## Project Level PM Quantitative Hot-Spot Analysis

### – Project of Air Quality Concern Questionnaire

Project Name:		Koli Road Traffic Interchange		Name: Lindsay Wickersham Agency: US EPA Region IX	
Project Number(s):	F0701 - Koli Road Traffic Interchange_PMI				
Document Name:	Consultation_12202024.pdf				
Document Date:	12/20/2024				
Page Number	Paragraph	Table	Other	Comment	COMMENT RESOLUTION For ADOT USE

## Re: Interagency Consultation: I-10 Koli Road Traffic Interchange 888-A(219)S | F0701 01L

Figure 2. Preferred Traffic Interchange DDI Alternative

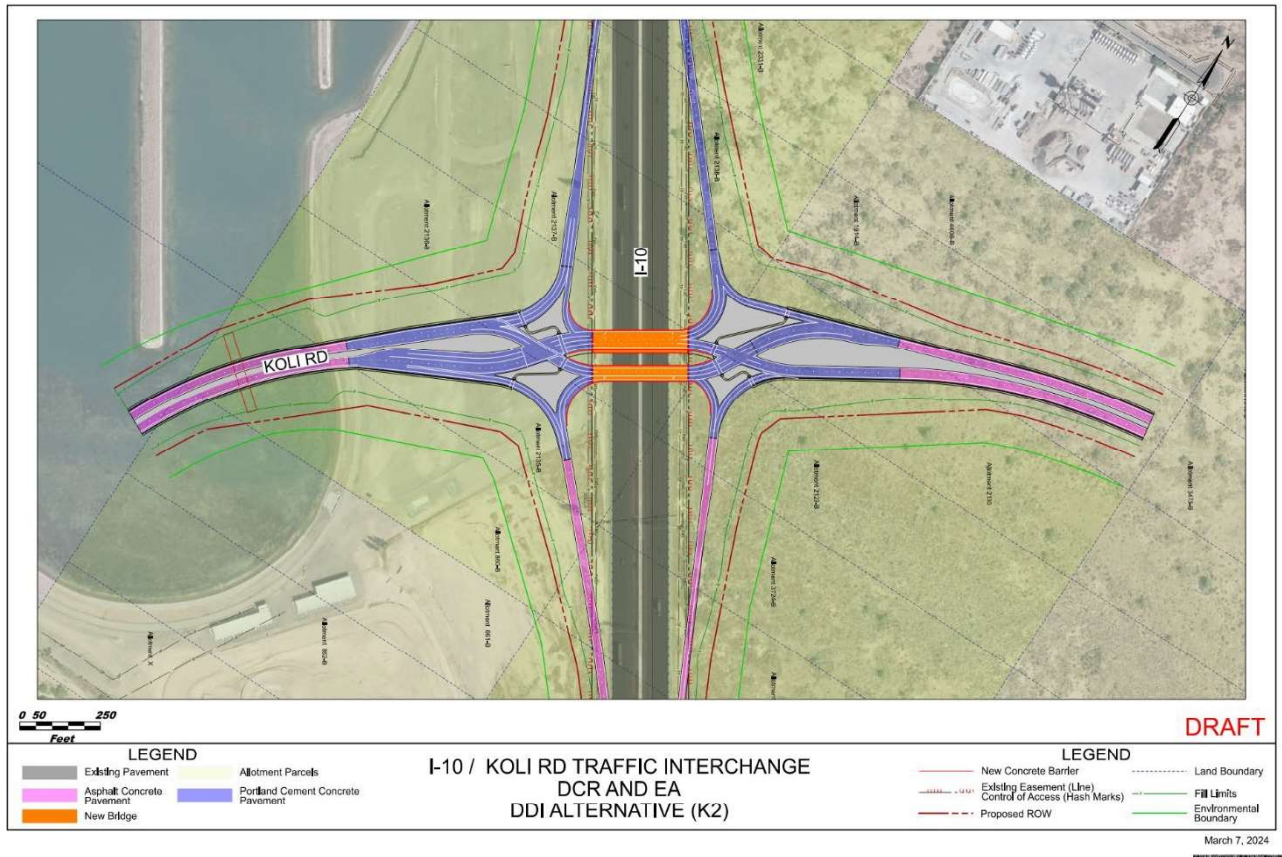
5	2			There is a misleading statement in this paragraph, "The total AADT is far lower than 125,000 and truck volumes are far less than 10,000 to be considered significant." The example referenced is an extreme case, and not the benchmark that should be used for a significant number of trucks. We recommend deleting or amending this statement.	Statement has been deleted.
5	4			On page 5, it states that this is not an expanded highway project, however there are new lanes being added to the project. We think this should be an expanded highway project and that this text should be amended.	The study scope is limited to the Koli Road TI, improvements to Wild Horse Pass Blvd TI and SR 347 Queen Creek Road TI are part of and independent project. These improvements were included as baseline existing conditions in both the No-Build and Build scenarios for Koli Road TI project.
5		1		There is traffic data included in this table for North and South of Koli Road on Maricopa Road, however there is no map or mention of where Koli road will meet Maricopa in this document. Please document where this road will be, and what type of interchange will be created to accommodate this new road.	New graphic provides project and "by-others" roadway network, i.e. north and south of Maricopa Rd connection (based on best available information). Additionally, figure 2 in the traffic memo provides traffic model segment and node connections.
